# HISTORIC AND DESIGN REVIEW COMMISSION

| **HDRC CASE NO:** | **2020-388** |
| **ADDRESS:** | 313 N PINE ST |
| **TYPE OF WORK:** | Construction of two, 2-story residential structures |

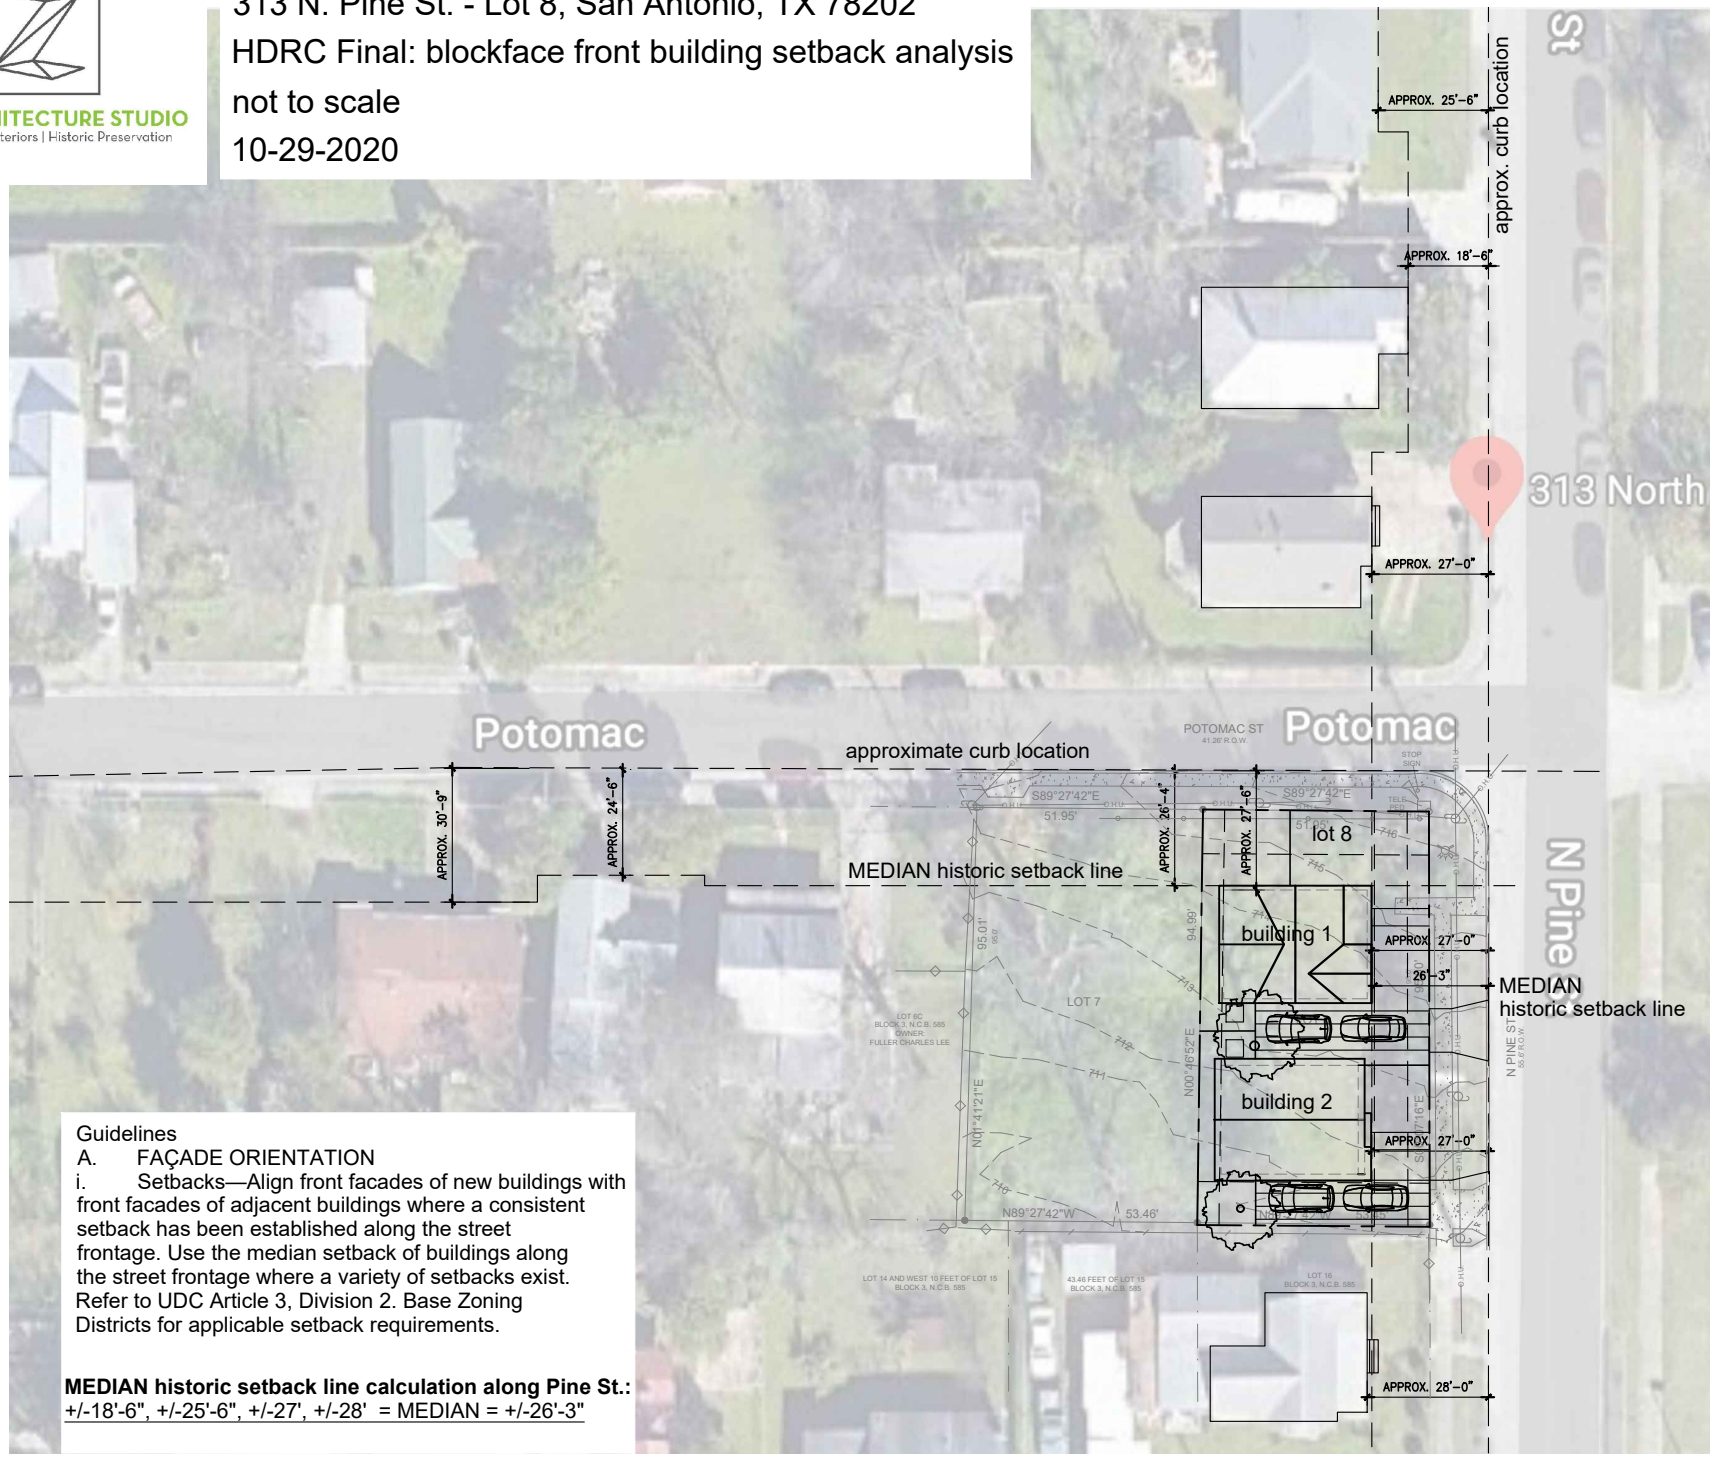
i. That both setbacks be greater than those found on the adjacent historic structures. Additionally, staff recommends that setbacks be measured from the front (street) face of the curb to ensure a uniform measurement. Staff recommends that the proposed setback diagram be revised to note a deeper setback. **This stipulation has not been met.**

f. SETBACKS – The applicant has submitted a site plan noting the proposed setbacks of both structures. The proposed new construction features setbacks that are equal to or greater than those found historically on the block. The measurement from the curb as noted on the site plan is not accurately represented as the historic house to the south is illustrated with a deeper setback than what is annotated. Staff finds that both structures should feature a setback that is deeper than the house at 303 N Pine (first house immediately located to the south of this site).

Staff recommends final approval based on findings a through u, with the stipulation that the proposed new construction feature increased setbacks that will result in both structures featuring a setback that is deeper than the house at 303 N Pine (first house immediately located to the south of this site).

**MEDIAN historic setback line calculation along Pine St.:**
+/-18'-6", +/-25'-6", +/-27', +/-28' = MEDIAN = +/-26'-3"

landscape site plan

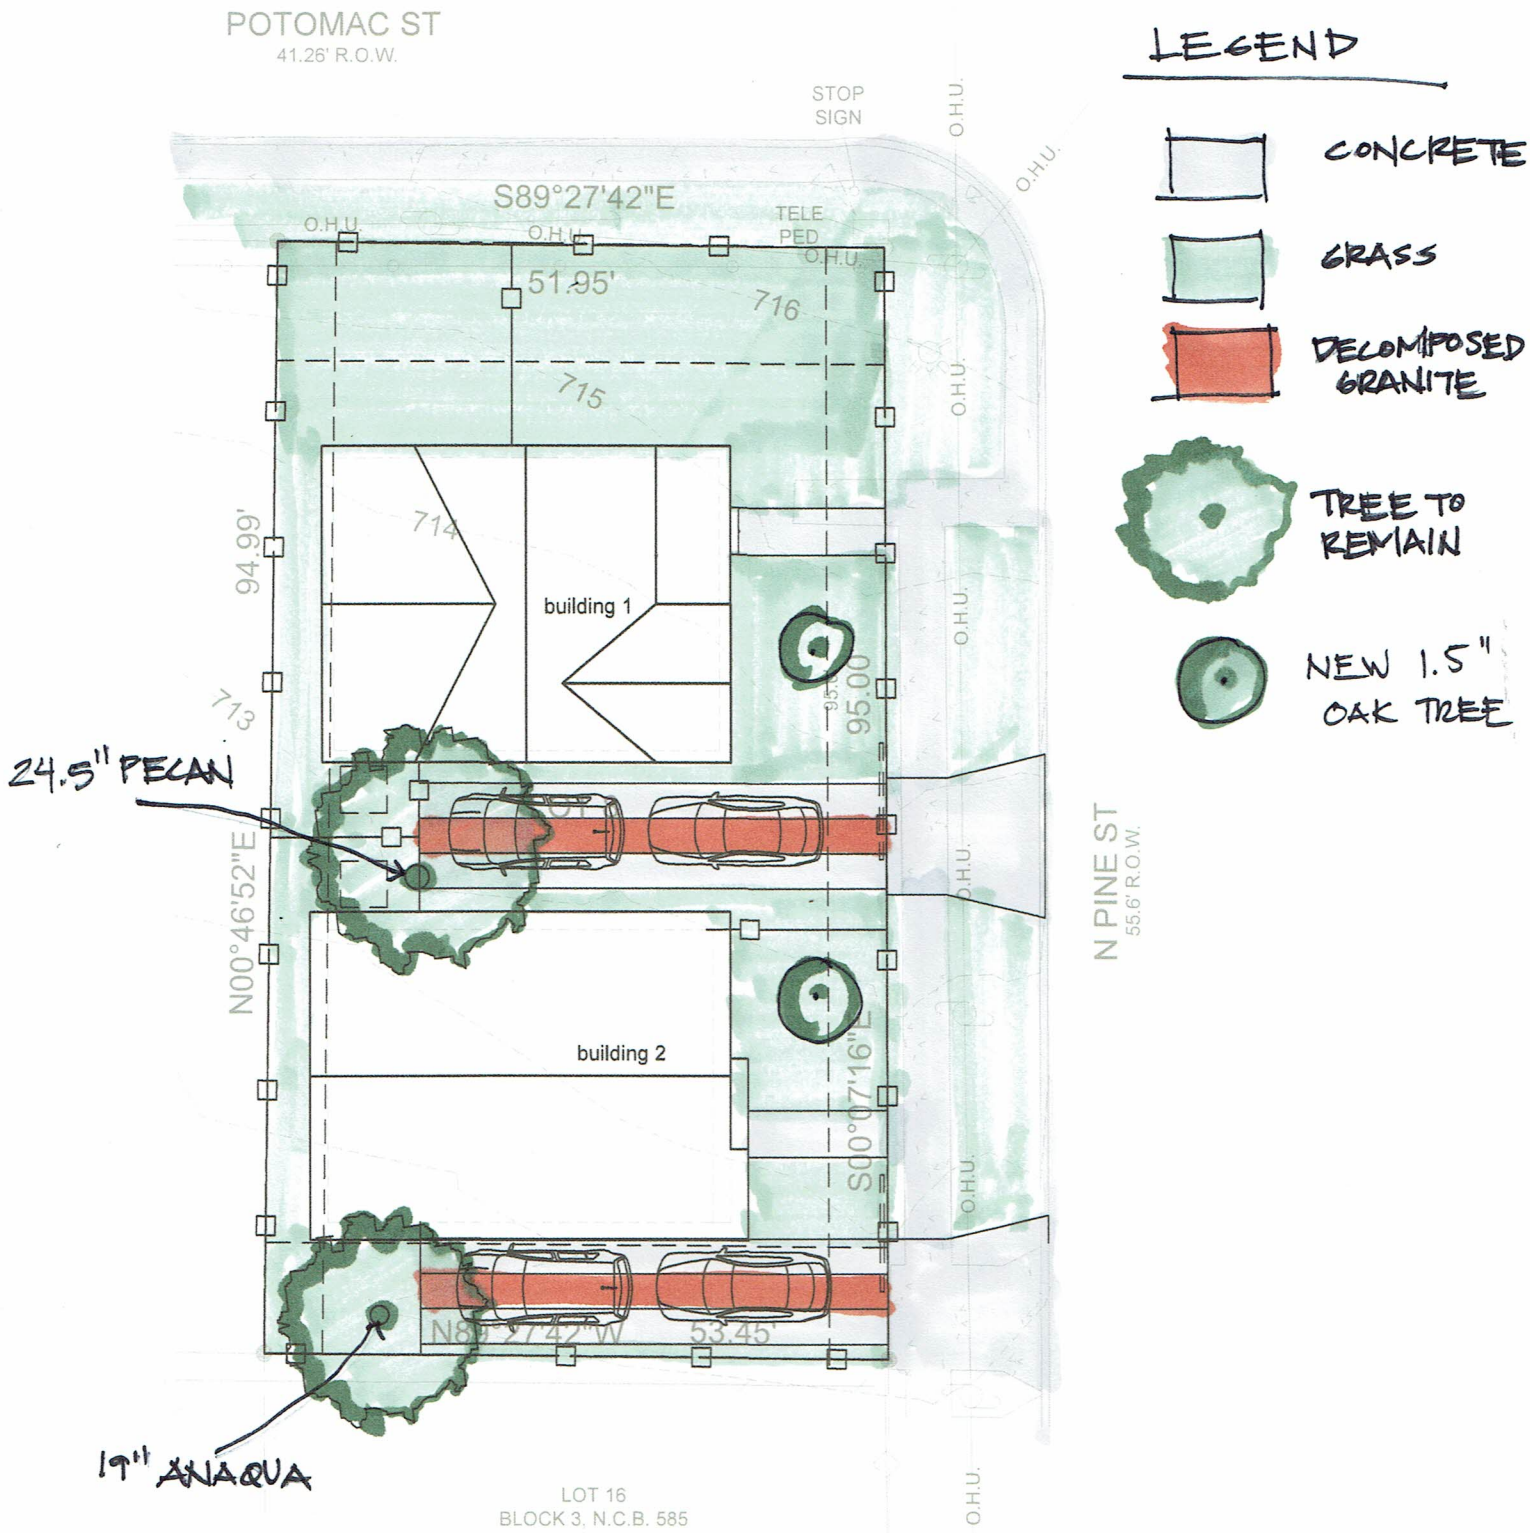
vii. That a landscaping plan be developed to be consistent with the Guidelines for Site Elements. ***This stipulation has been met.***

r. SITE ELEMENTS (Walkways) – The applicant has proposed to install walkways that lead from the front porch to the right of way. Staff finds the proposed concrete walkways to be appropriate and consistent with the Guidelines.
s. SITE ELEMENTS (Landscaping) – The applicant has submitted a landscaping plan that is consistent with the Guidelines for Site Elements.
t. SITE ELEMENTS (Fencing) – The applicant has proposed the installation of both front yard, cattle panel and rear privacy fencing. The proposed front yard fence will not exceed four (4) feet in height, while the proposed privacy fence will not exceed six (6) feet in height. The proposed fencing is appropriate and consistent with the Guidelines.
u. MECHANICAL EQUIPMENT – The applicant has noted the location and screening of mechanical equipment.

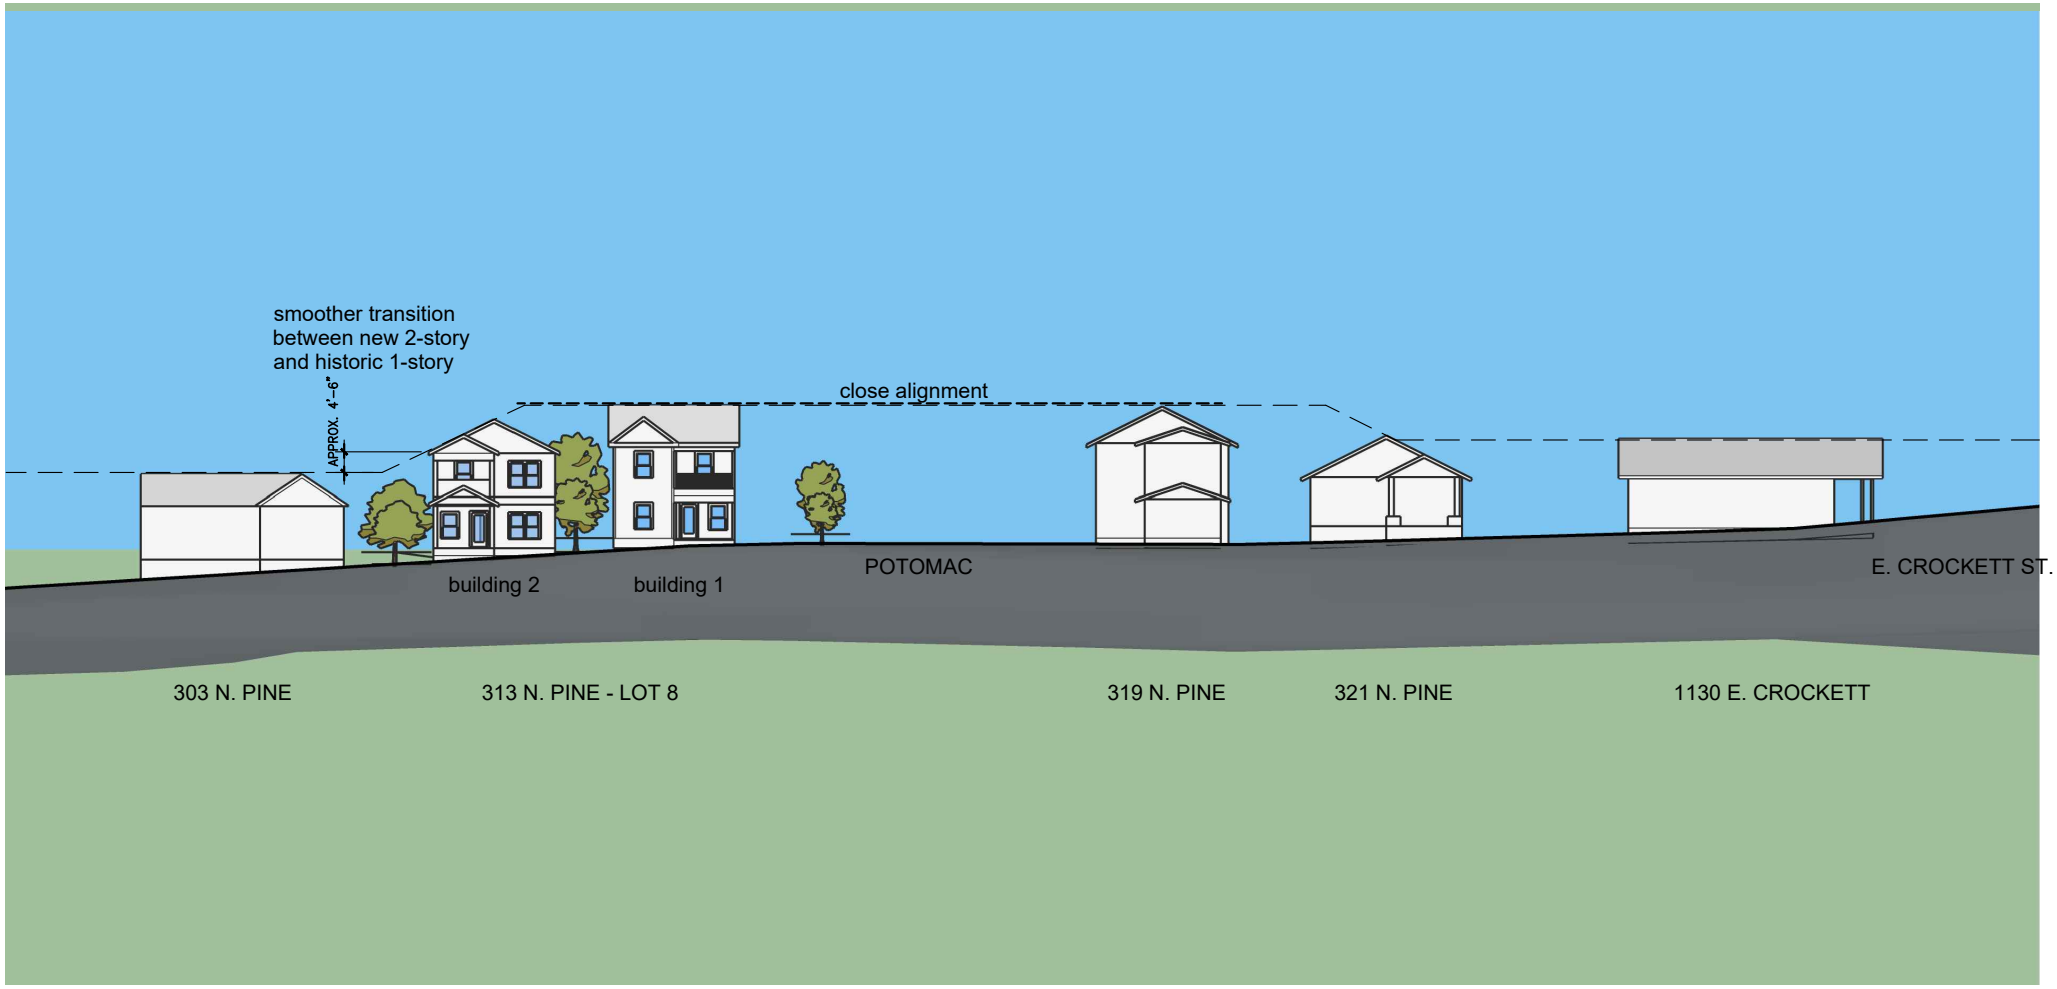
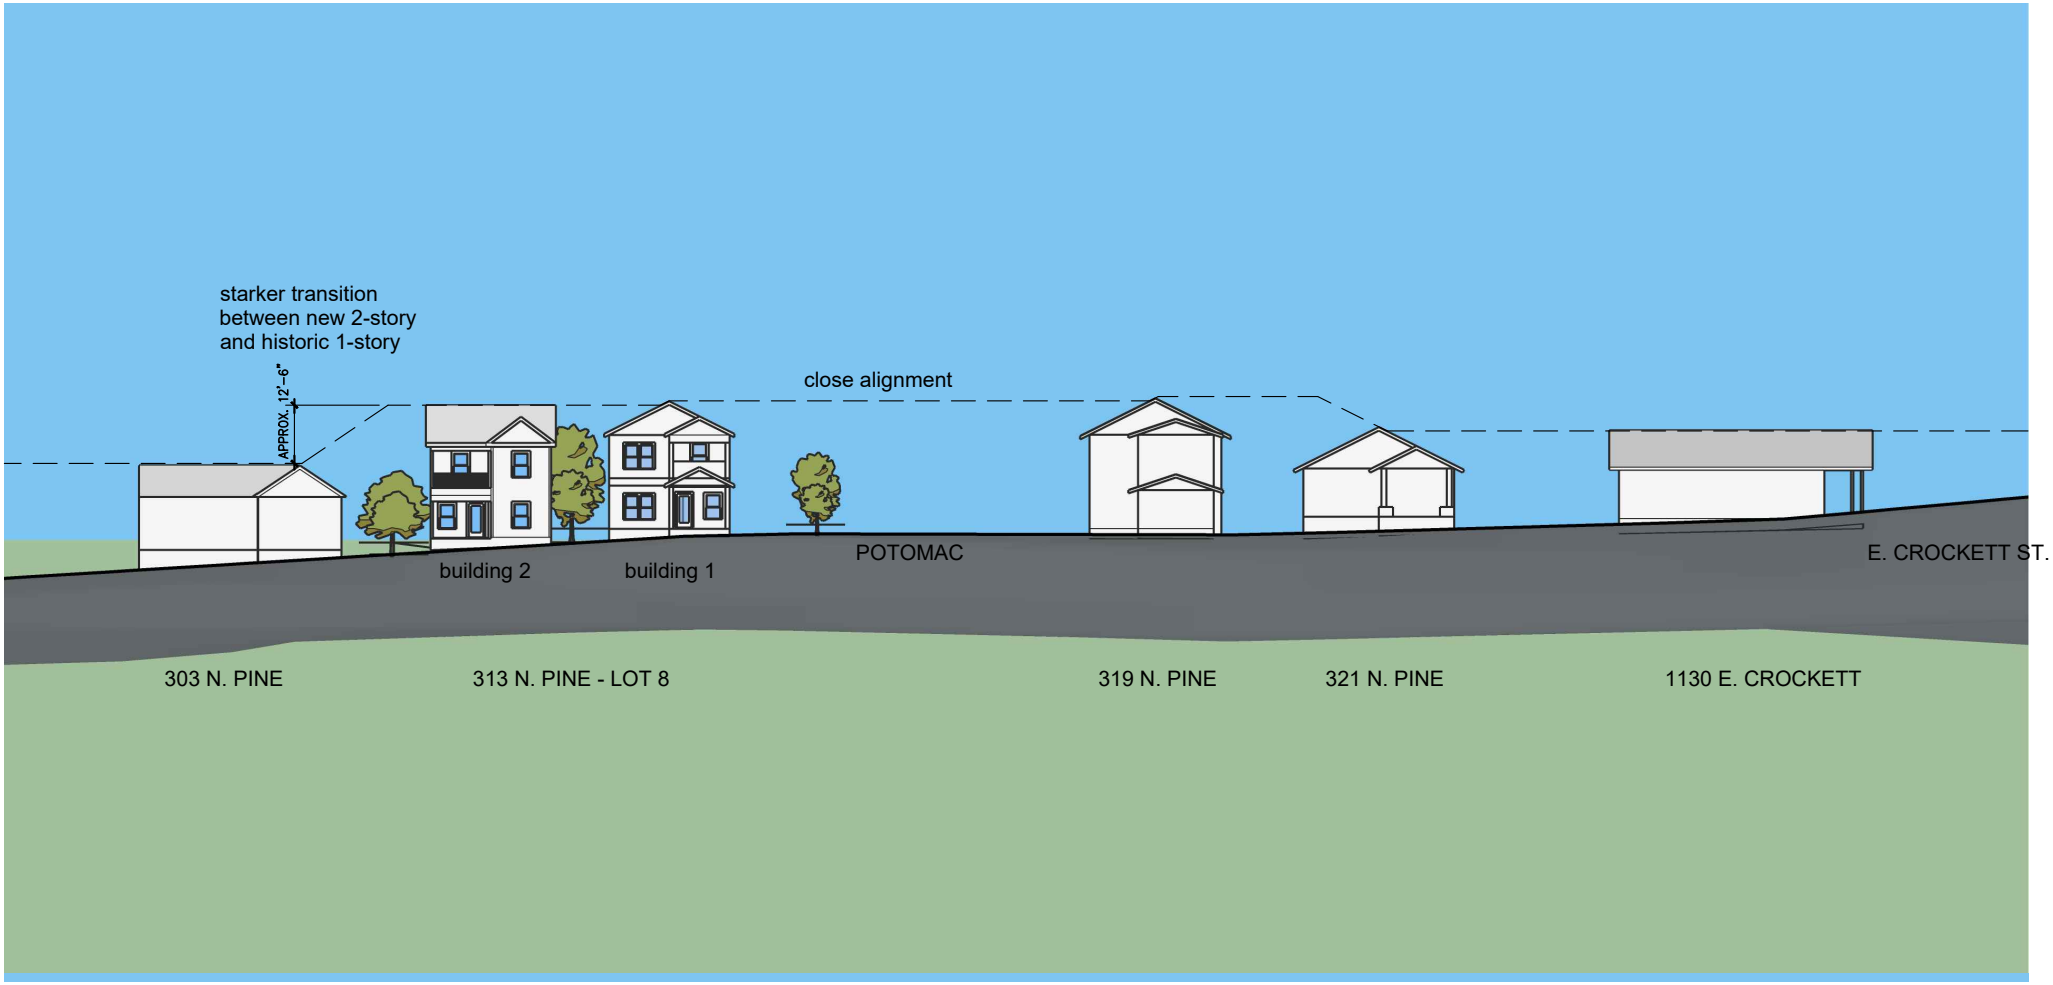
**COMMENTS/CONCERNS:**
FZ: Overview of proposed setbacks in relationship to adjacent, historic structures
AMG: Can the setback of building two be increased to be set behind the property to the south? The proposed two story massing in addition to the reduced setback is may be inappropriate.
GV: Appreciates the proposed design (overhangs) as proposed. Relates to the historic structures within the district.
FZ: House can be pushed back to increase the setback; however, the houses will lose square footage.
JF: Questions regarding building 1's setback. The primary issue and concern is the fact that building two is in front of the historic house to the house. Can the two houses be flipped in their location and a gable roof be used adjacent to the lot to the immediate note of the one story historic structure. The houses will not need to be reduced in size.
FZ: Does not want to locate the Craftsman house at the corner to be immediately across the street from a historic Craftsman structure.

During our DRC meeting on 10/27/2020, it was suggested that one strategy to alleviate our minimum front setback requirements would be to explore flipping Building 1 and Building 2 on the site plan, allowing for the corner condition to have a lesser front setback, very typical of the neighborhood. Additional exhibits illustrate the exploration of this alternative solution, however we noticed it created a harsher transition between the proposed 2-story structures and the neighbor directly to the South.
